**The First Meeting of the Aerodrome Operations and Planning Sub-Group
(AOP/SG/1)**

**PROPOSALS FOR THE AMENDMENT OF ANNEX 14, VOLUME I AND
PANS-AERODROMES (DOC 9981)**

Ref.: AN 4/1.1.57-17/44

Subject: Proposals for the amendment of Annex 14,
Volume I and PANS-Aerodromes (Doc 9981)

1. Runway widths and shoulders (Annex 14, Volume I, paragraph 3.1.10)

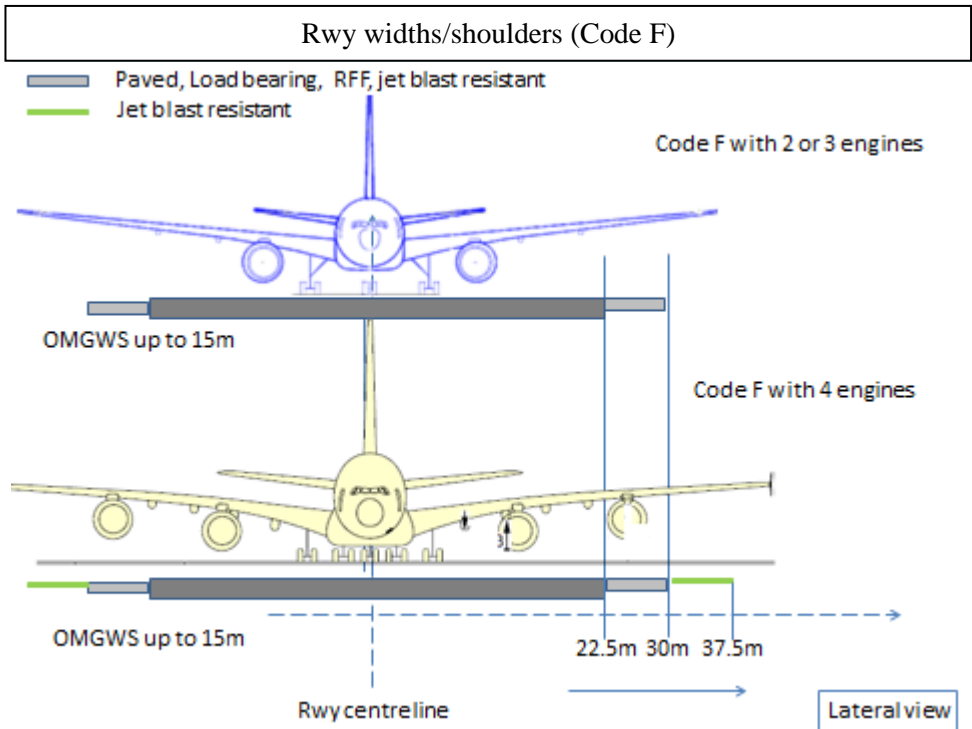
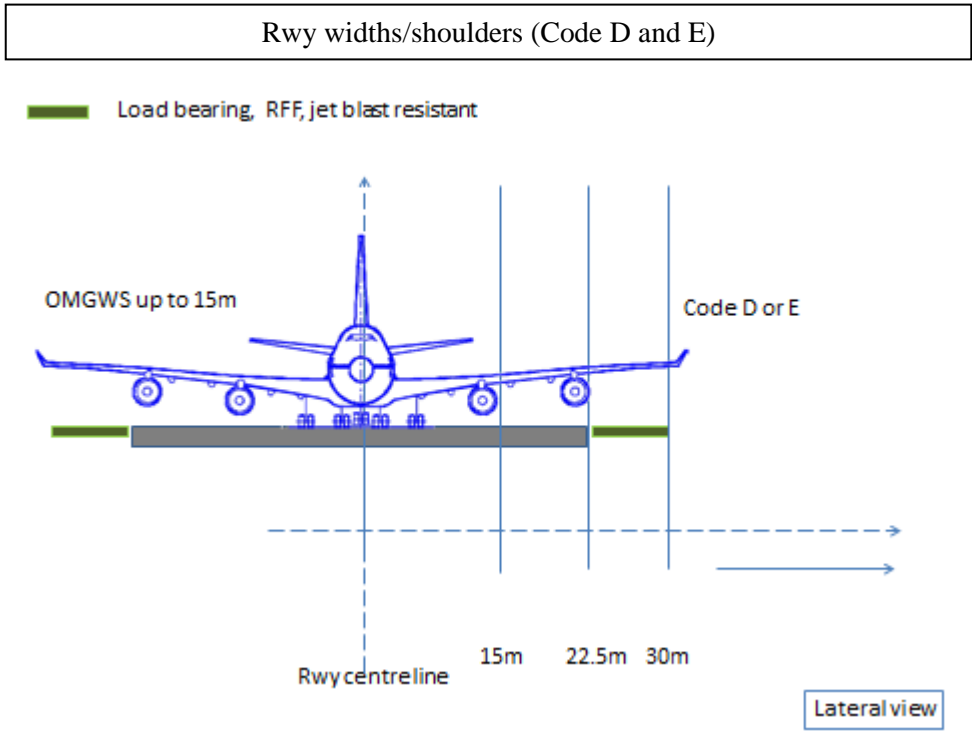
1.1 The following diagrams show the different runway and shoulders for OMGWS above 6m and up to 15m (covering nearly all commercial aeroplanes, Codes C, D, E and F)

3.1.10 **Recommendation.**— *The width of a runway should be not less than the appropriate dimension specified in the following tabulation:*

Code number	Outer Main Gear Wheel Span (OMGWS)			
	Up to but not including 4.5 m	4.5 m up to but not including 6 m	6 m up to but not including 9 m	9 m up to but not including 15 m
1 ^a	18 m	18 m	23 m	
2 ^a	23 m	23 m	30 m	
3	30 m	30 m	30 m	45 m
4			45 m	45 m

2. Taxiway widths and shoulders (Annex 14, Volume I, paragraphs 3.9.3, 3.9.4 and 3.10.1)

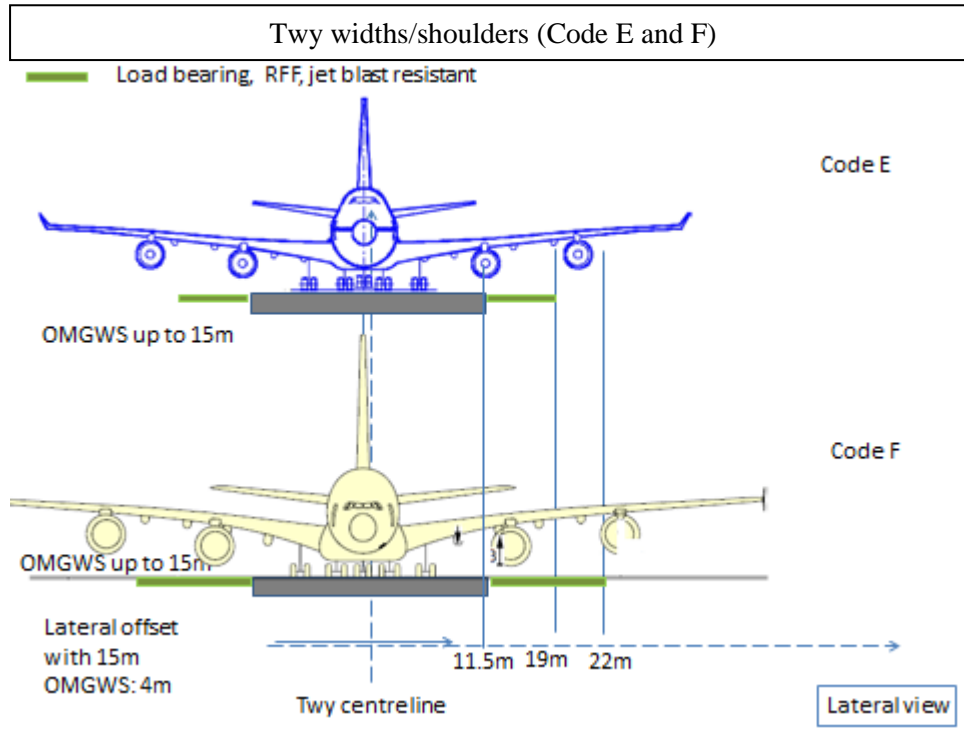
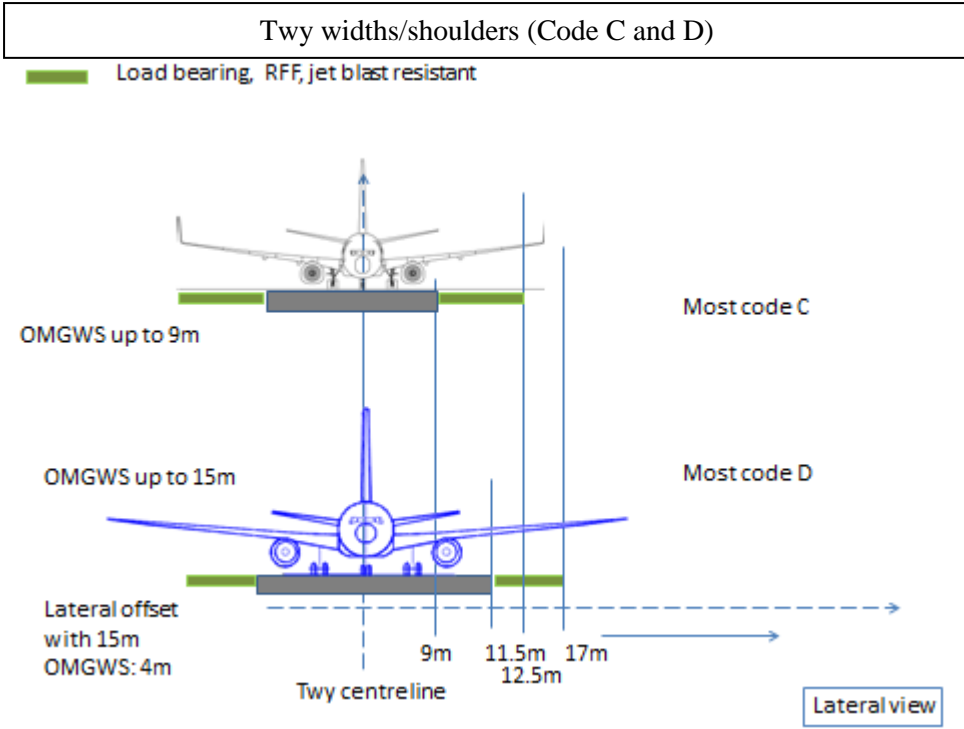
2.1 The following diagrams show the different taxiway and shoulders for OMGWS above 6m and up to 15m (covering nearly all commercial aeroplanes, Codes C, D, E and F).

3.9.4 **Recommendation.**— *A straight portion of a taxiway should have a width of not less than that given by the following tabulation:*

OMGWS			
	Up to but not including 4.5 m	4.5 m up to but not including 6 m	6 m up to but not including 9 m	9 m up to but not including 15 m
Taxiway width	7.5 m	10.5 m	15 m	23 m

Graded portion of a taxiway strip in relation to taxiway to object distance according to Table 3-1 .

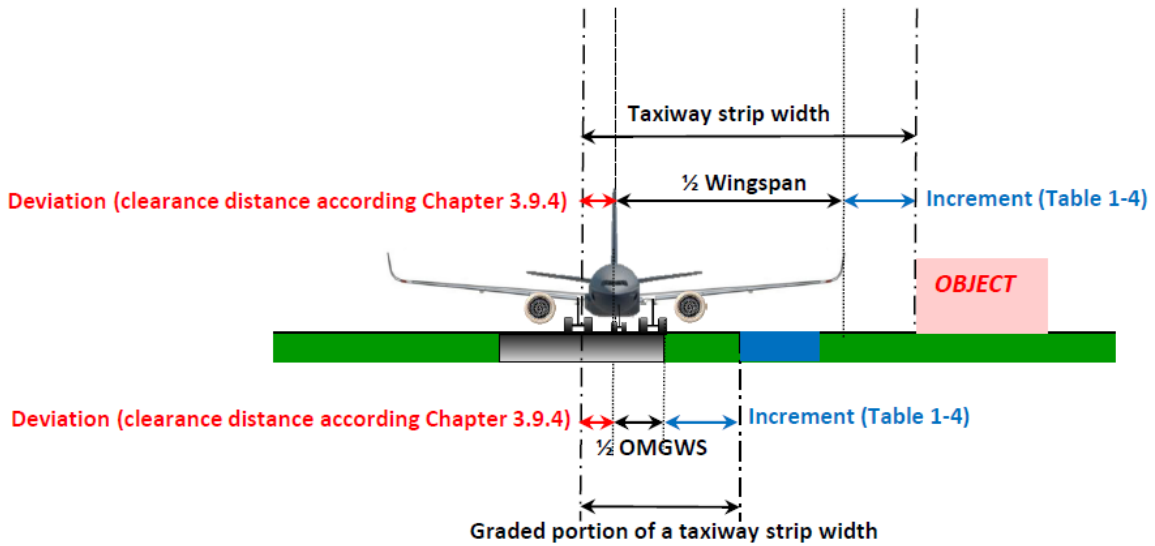
4.3 The proposed values are consistent with the revised taxiway separations distances in Table 3-1 as per Amendment 13, Annex 14, Volume I. The proposed amendment simplifies the application of airport planning standards as well as allowing a more efficient use of aerodrome land surface by applying the same safety level for a wingtip collision as for getting beyond the graded portion of a taxiway strip in case of an excursion.

- ~~11 m where the code letter is A;~~
- ~~12.5 m where the code letter is B or C;~~
- ~~19 m where the code letter is D;~~
- ~~22 m where the code letter is E; and~~
- ~~30 m where the code letter is F.~~
- 10.25 m where the OMGWS is up to but not including 4.5 m
- 11 m where the OMGWS is 4.5m up to but not including 6 m
- 12.50 m where the OMGWS is 6 m up to but not including 9 m
- 18.50 m where the OMGWS is 9 m up to but not including 15 m
